### About this application note

This application note seeks to correct a problem that may occur when using the **In Situ Programming (ISP)** feature on **ST7MDT1-DVP2** and **ST7MDT2-DVP2** development kits.

## Workaround to ISP Mode Limitation on the ST7MDT1-DVP2 and ST7MDT2-DVP2

Figure 3: Location of ISP driver chip on the ST7MDT2-DVP2

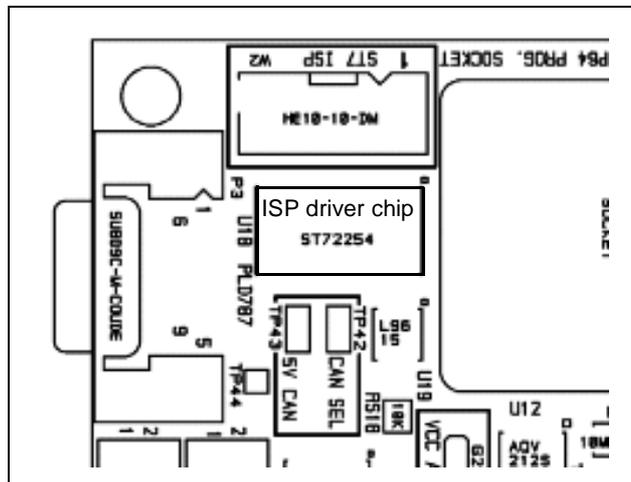
- 1 Locate the ISP driver chip (ST72254), in the corner of the DVP board, close to the ISP connector. *Figure 3* shows the location of the driver chip (labelled U18) for the ST7MDT2-DVP2. The driver chip is in a similar location (labelled U17) on the ST7MDT1-DVP2.

- 2 Once you have located the ST72254 ISP driver chip, find pin 1 of the chip which is indicated by an indentation in the top of the chip's package.
- 3 Solder the following pins together:
  - Pins 8, 9, 10, 11
  - Pins 15, 16, 17, 18

- 4 Solder one end of an insulated wire from Pins 8, 9, 10 and 11 (which are already soldered together). Solder the other end of the same insulated wire to Pins 15, 16, 17 and 18 (also soldered together).

- 5 Take a second insulated wire, and solder the first end to Pins 15, 16, 17 and 18 (soldered together) and the other end to pin 20.
